Emeric Construction Submittal # 0500-1
 This drawing or submittal has been reviewed for compliance with plans and specifications and coordination with the work of others. Approval does not relieve supplier or subcontractor of responsibility for errors, omissions, or non-compliance with the contract documents.
 Approved Approved as noted
 Revise and resubmit
 By: *[Signature]* Date: 1-26-95

FABRICATION PRODUCTS
 6131 NE. 63 rd. Street
 Vancouver, WA 98661
 Phone (360) 696-1324

DRAWN BY	DATE	CUSTOMER	CITY OF McMinnville	CONTRACT NO.
CHECKED BY	DATE	STRUCTURE	McMinnville Comm. Center	DWG NO.

Emerick Construction Submittal # 0500-2
 This drawing or submittal has been reviewed for compliance with plans and specifications and coordination with the work of others. I approved does not relieve supplier or subcontractor of responsibility for errors, omissions, or non-compliance with the contract documents.
 Approved Approved as noted
 Advise and resubmit
 By: [Signature] Date: 2-20-95

4C (L 4x4x1/4) 10'-0" REQ'D.
(REF. B/E2) (GALV.)

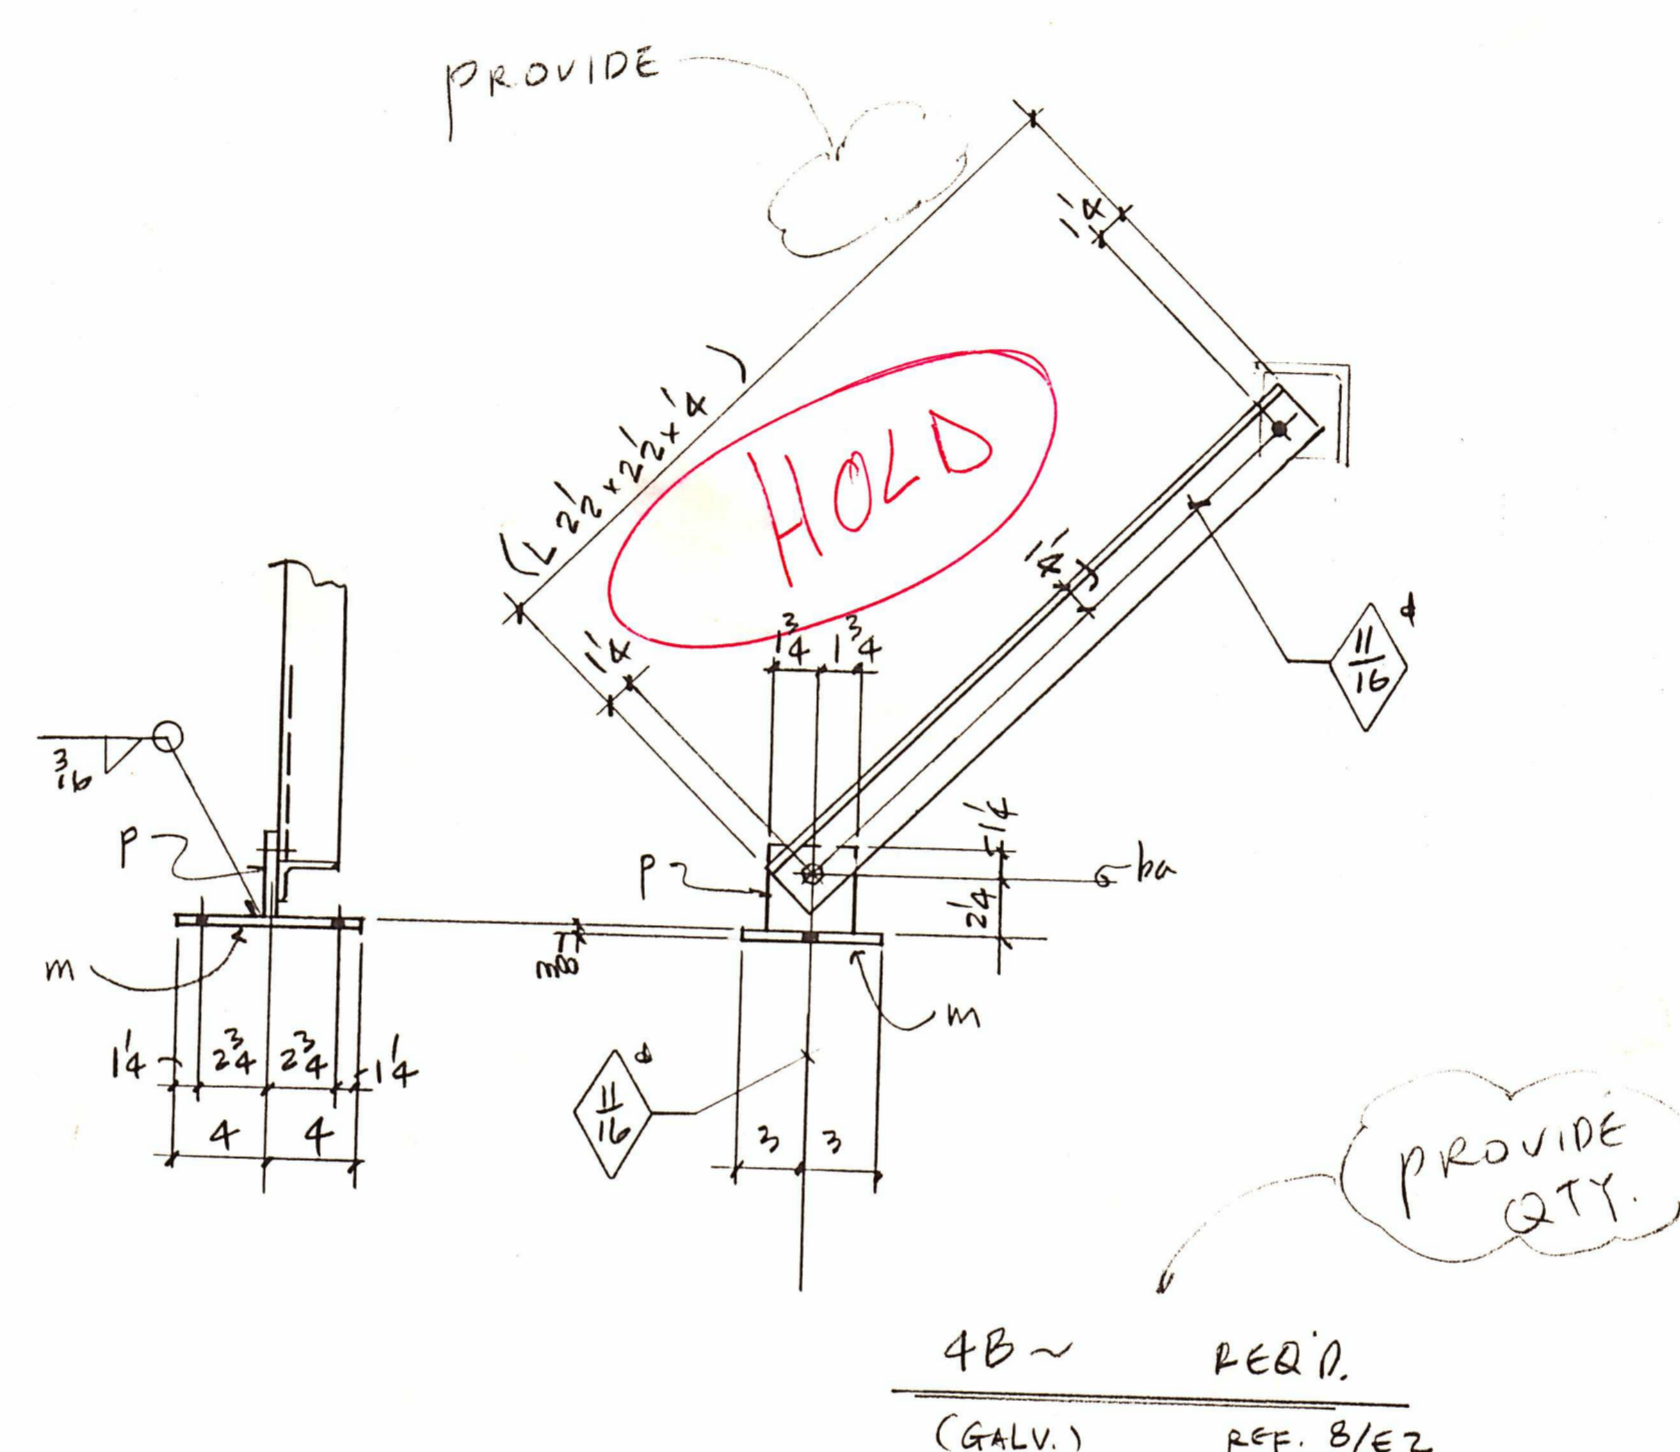
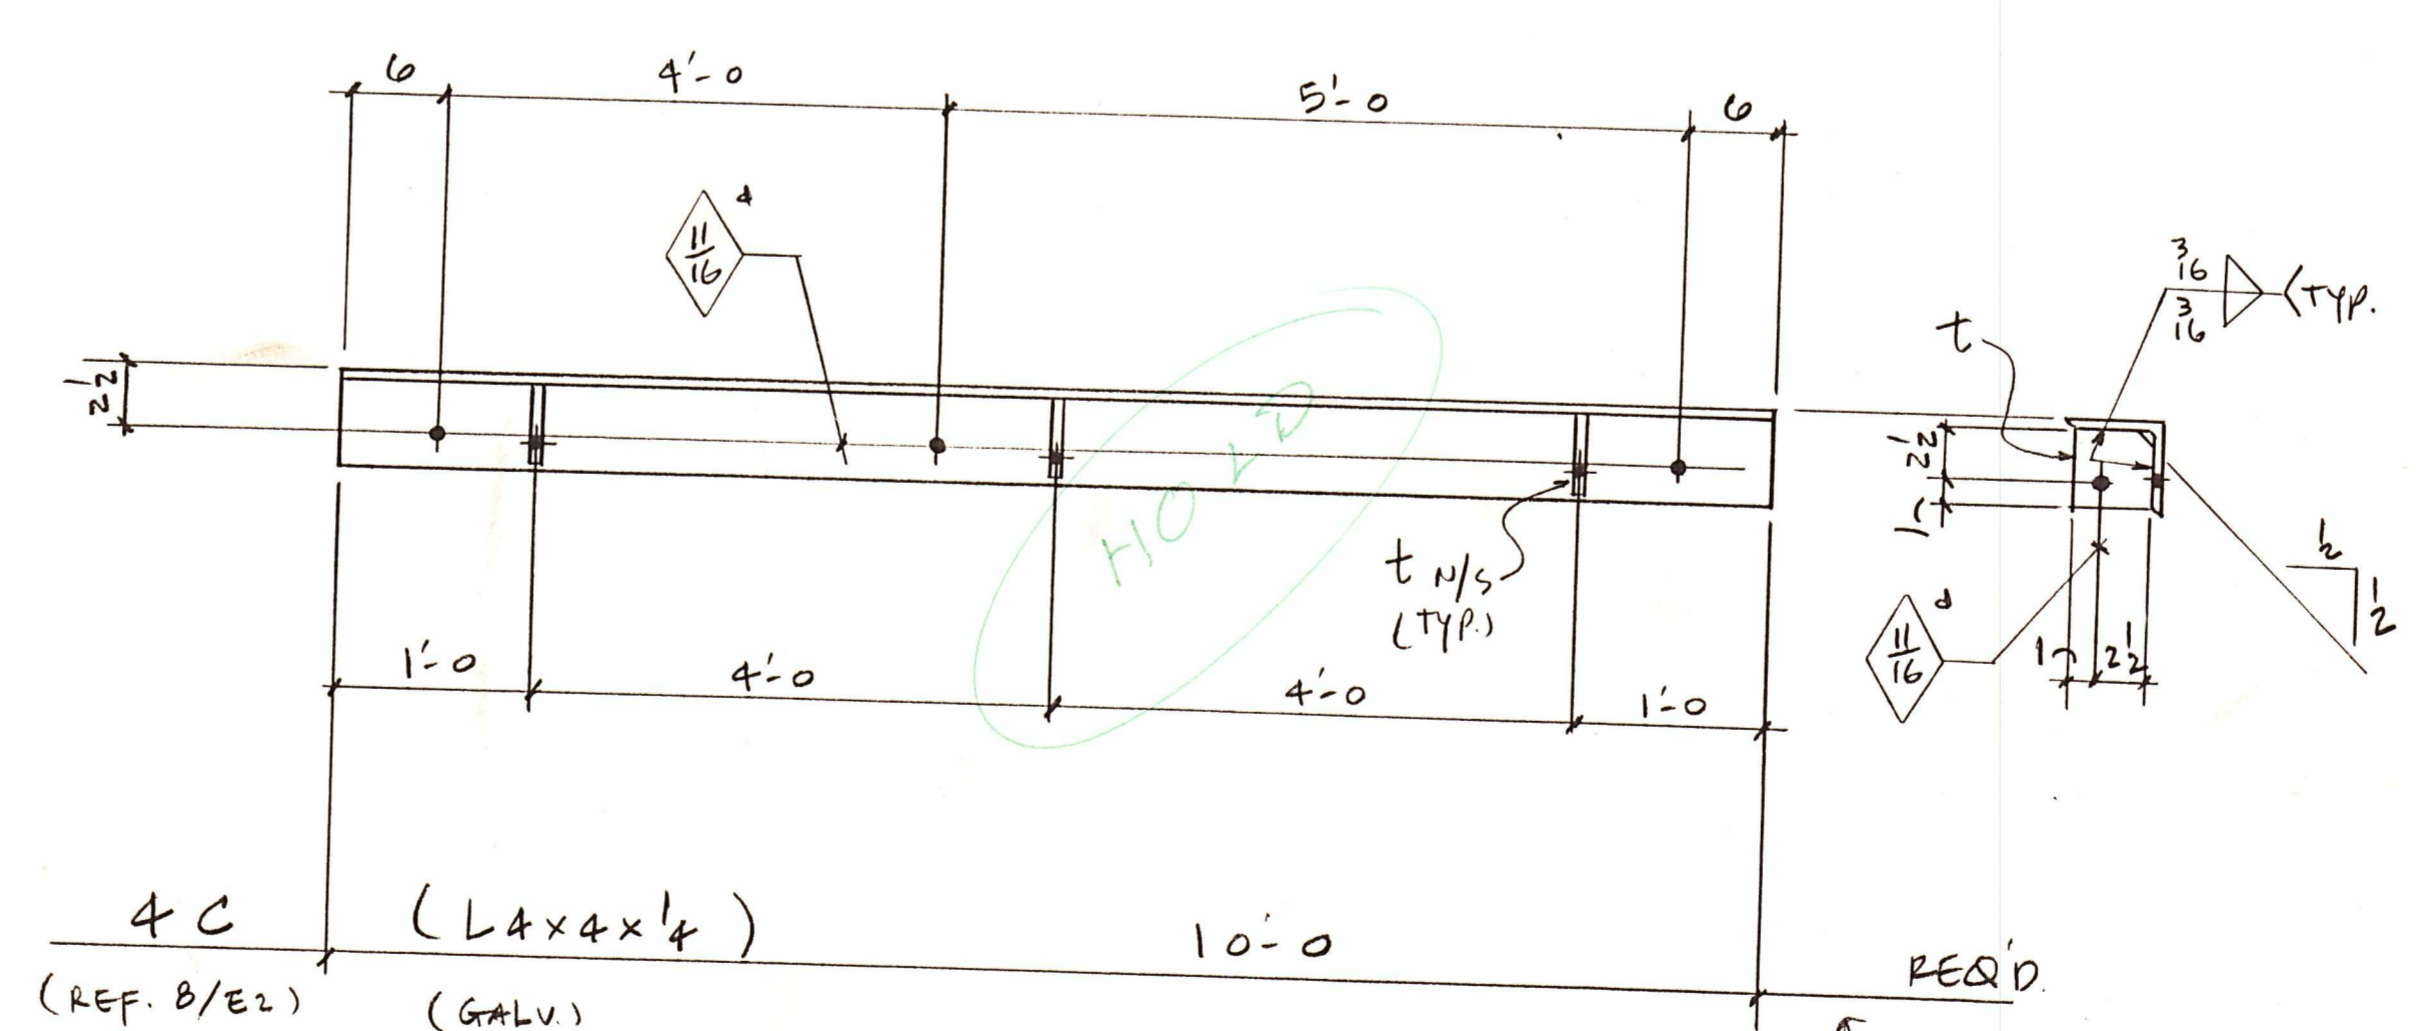
PROVIDE QTY.

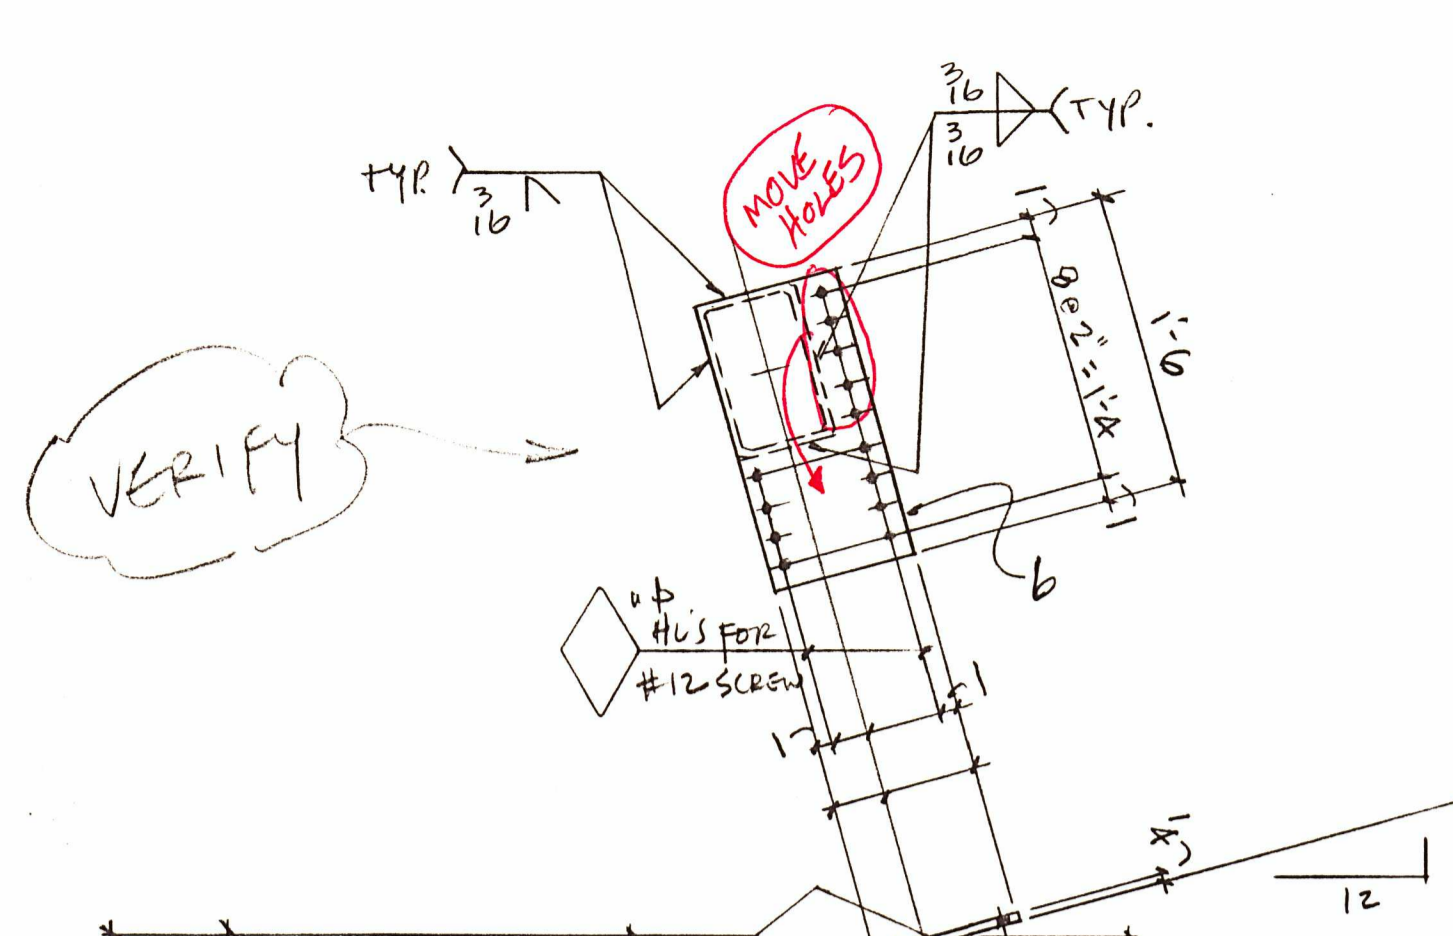
VERIFY

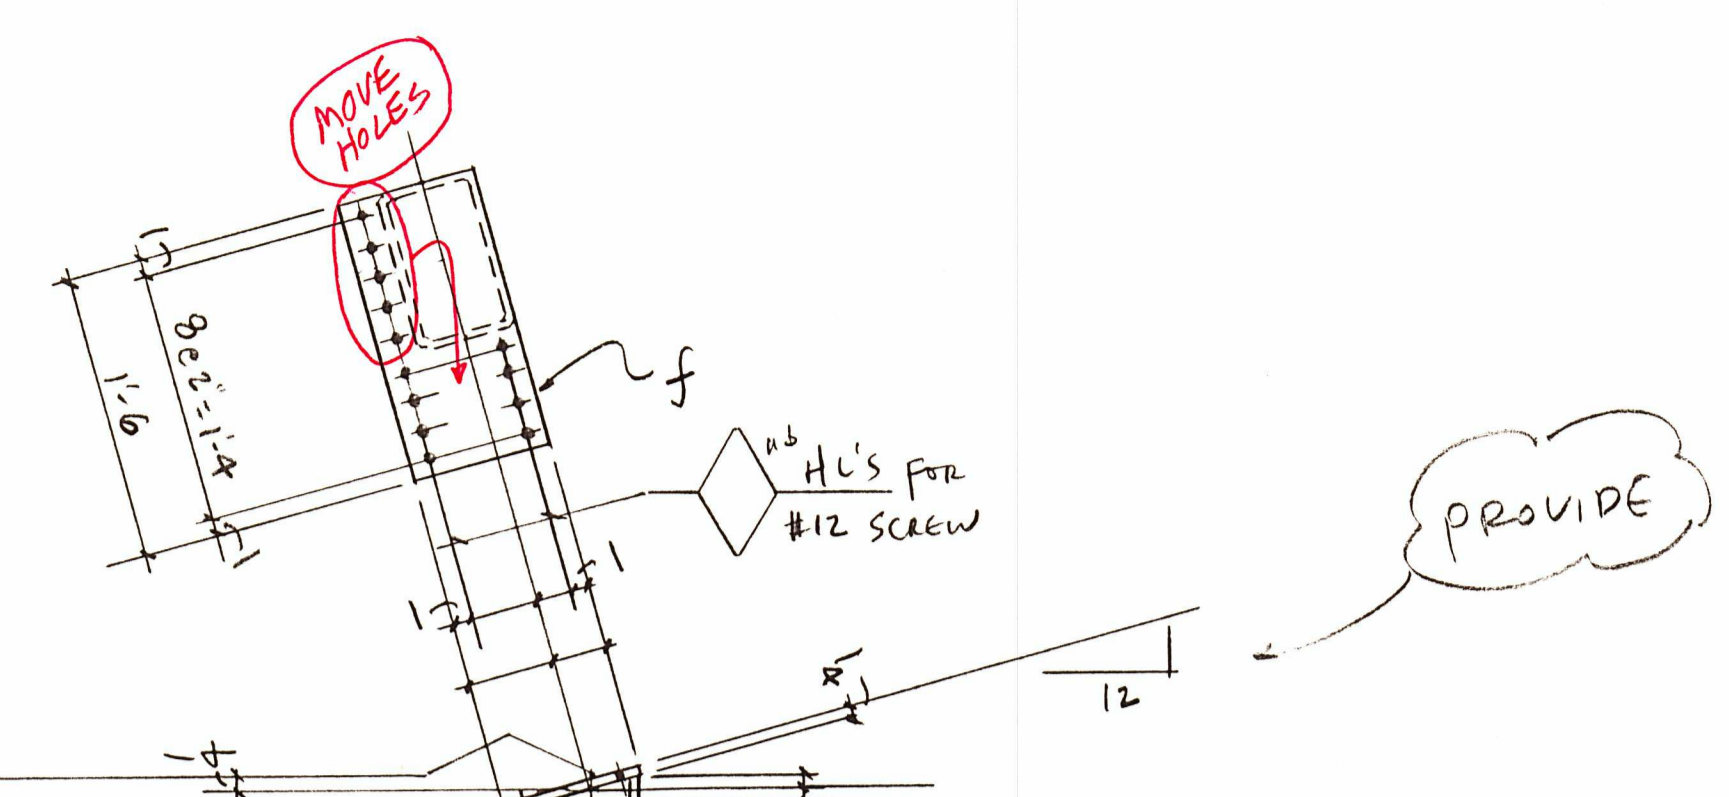
PROVIDE
